STAFF REPORT: 7/10/2024 MEETING

ADDRESS: 1480 SHIPHERD

APPLICATION NO: #HDC 2024-00086

SCOPE: ERECT NEW ADDITION, ALTER EXTERIOR OF BUILDING

1480 Shipherd, prior to unapproved work. Photo provided by applicant

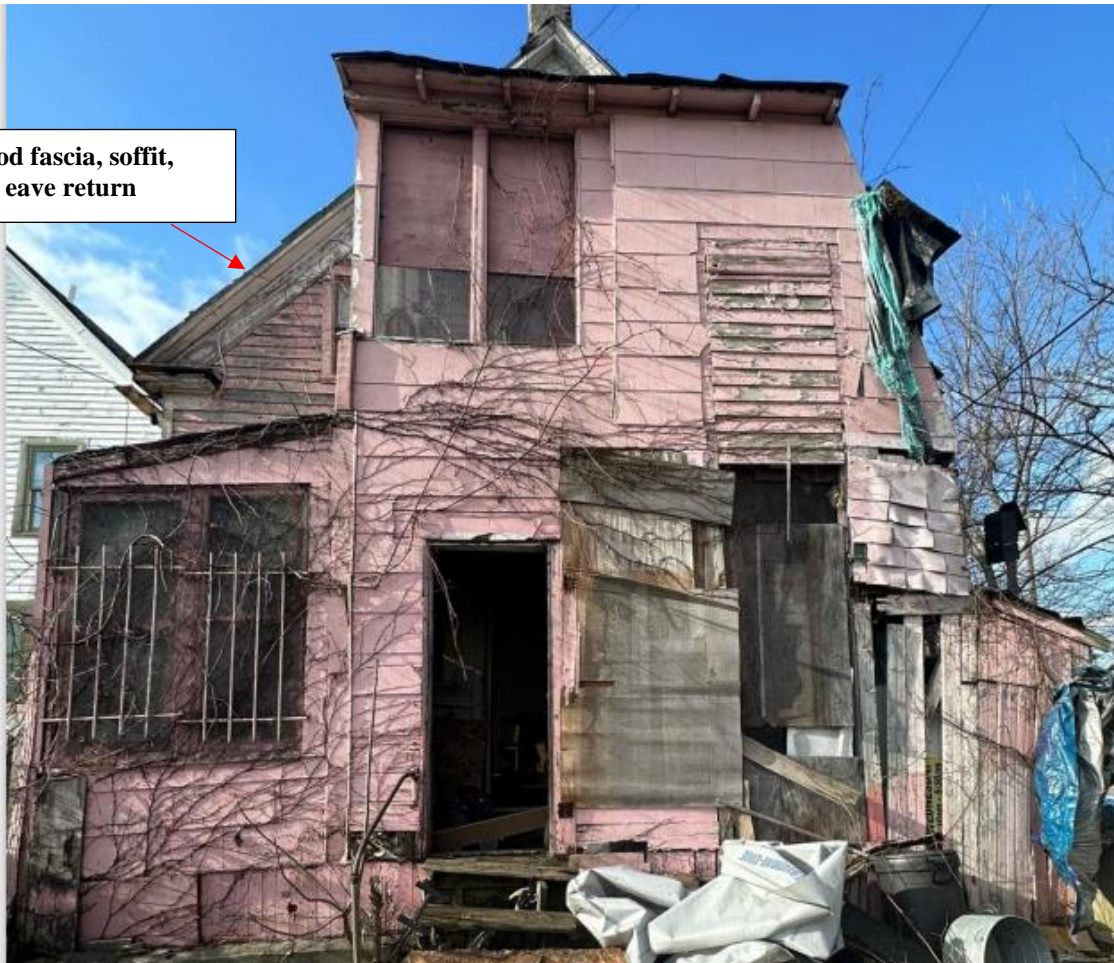
Narrow exposure wood clapboard siding

Pedimented gable end with stepped wood fascia sunburst patterned panels

Wood trim and soffits at side wall

Note that lapped siding at the side wall has a wider exposure than the lapped siding at the front facade

It is staff's opinion that all distinctive, character-defining elements which were removed from the house, as outlined in the above annotated photos, should be replicated and resotred per their historic appearance as their removal does not meet the Standards.

North (top) and south (bottom) elevation, proposed conditions

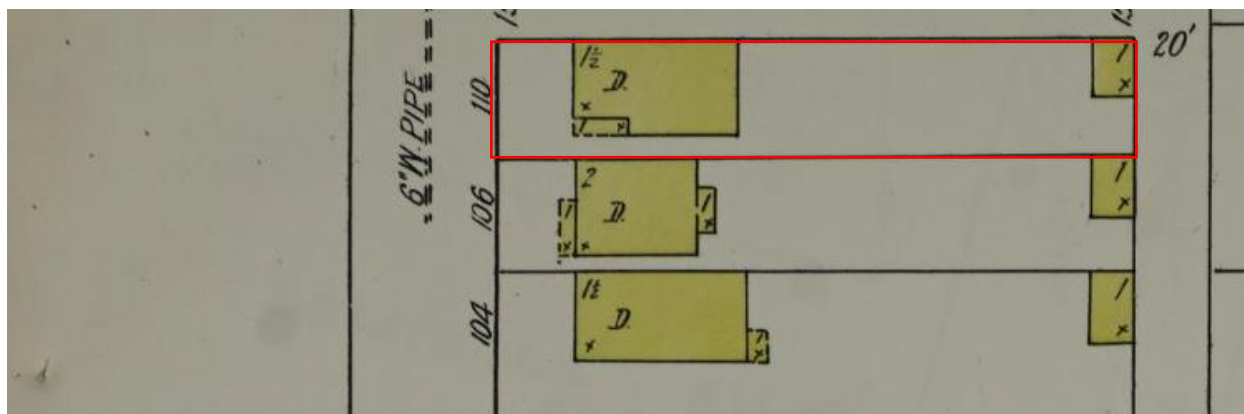
- The fish scale shingle treatment proposed for the east gable is not accurate to the sunburst panel siding that was historically located within the gable/removed without approval

- The proposed treatment for the soffit/fascia areas at the side walls and the front façade porch do not appear to match the level of detail that was originally present/removed without approval

- The application also appears to seek to replace the double-hung windows which were removed from the north elevation with new sliding units.
 - The exposure dimensions of the new lapped wood siding will not match that of the original siding/the siding that was removed without HDC approval.

- The drawings indicate the presence of slider windows at the side walls, however all remaining windows at these locations appear to be 1/1, double hung units. Also, the drawings note that the existing windows will be retained, but staff is unclear if the notes are incorrect and the applicant is instead intending to install sliding units at these locations as depicted in the drawings.
